A/T - No Reverse/3rd or 5th Gear/MIL ON/DTC P0776

Bulletin No.: 09-07-30-012F

Subject: No Reverse, 3rd or 5th, Check Engine Light Illuminated, DTC P0776 (Replace 3-5 Reverse Clutch Plate (Waved)

All Equipped with 6T70/75 6-Speed Automatic Transmission (RPOs MH2, MH4, MH6 or MY9)

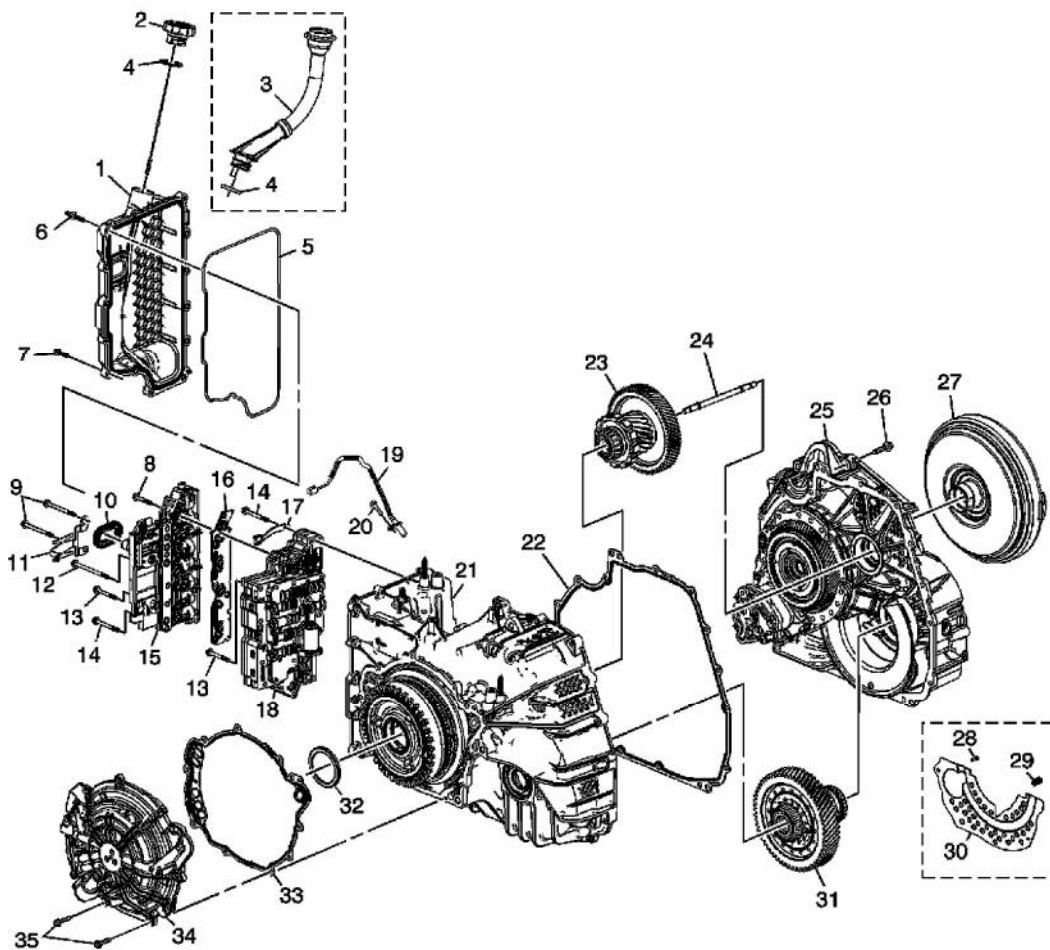
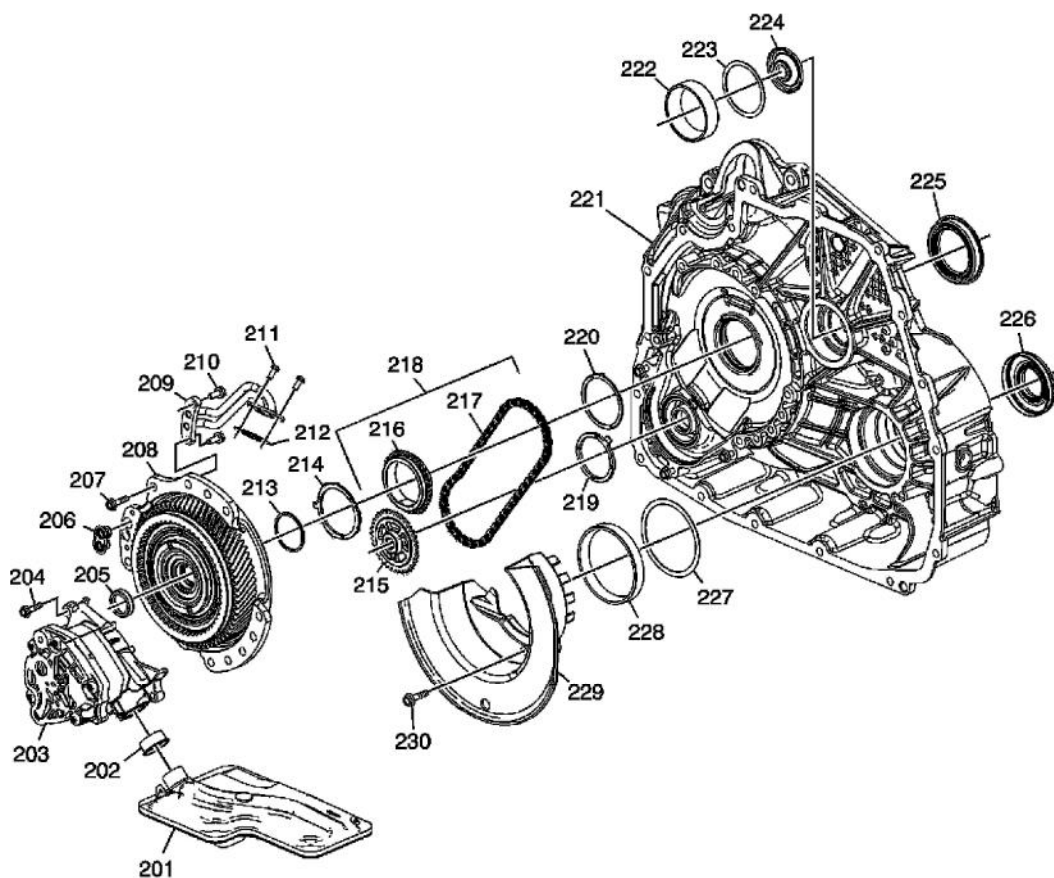
1. After removing the transmission from the vehicle, remove the case cover assembly (35). Inspect the case cover for damage. This part is serviced and can be replaced if it is damaged.
2. Remove the 35R/456 clutch housing assembly (422) and inspect it for a broken 35R wave plate (423).
3. Inspect the case (21) for damage caused by a broken wave plate as shown below.

- The snap ring groove, which is well below the 3-5-R wave plate area, is unlikely to be damaged. It should still be checked to verify the snap ring is fully seated and to be securely retained.

- Peening or wear of the face or edge of the case lugs that engage the steel clutch plates is normal and not cause for transmission replacement.

- Some degradation of the shelf for the 2-6 backing plate is acceptable as long as the plate can lie flat. A raised burr that prevents this can be removed using a de-burring tool, file or some other abrasive.

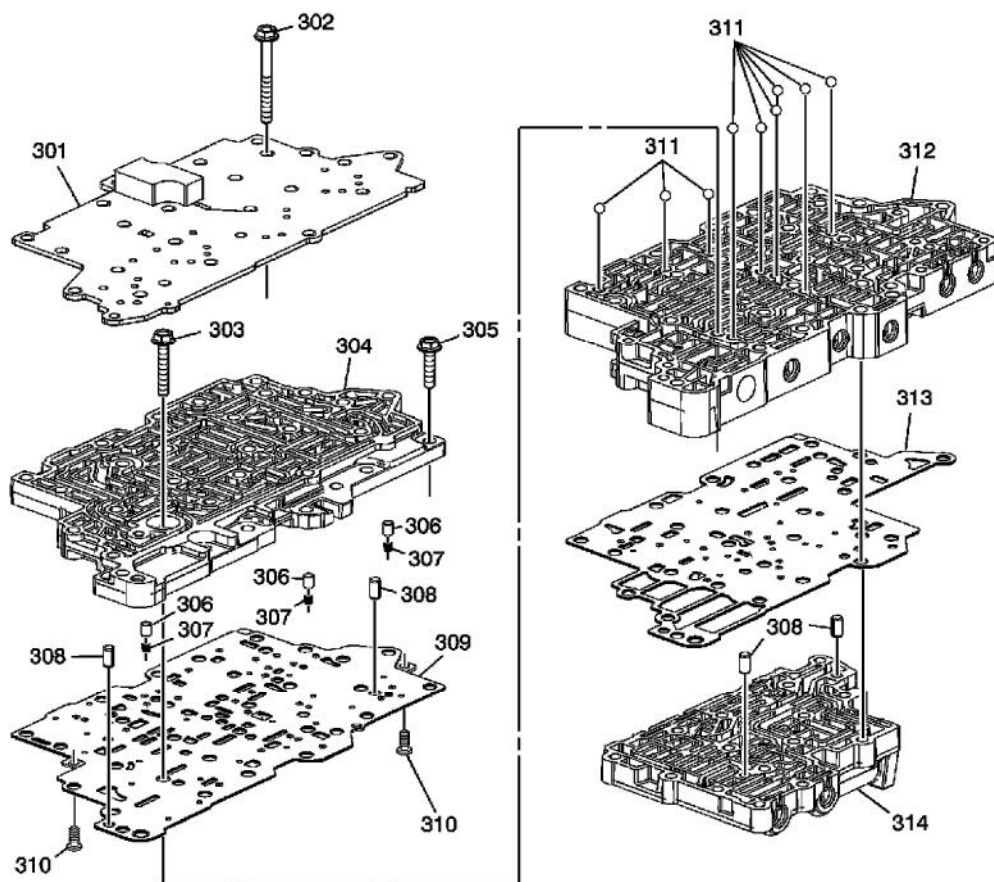
6. Inspect the control solenoid (w/body and TCM) valve assembly (TEHCM) (15) pressure switches. The O-ring seals may be deformed but if they are attached, as shown above, the TEHCM should not be replaced; it should be reused. Deformed seals do not affect switch performance.

If any of the switch membranes are damaged, as shown above, the TEHCM must be replaced.
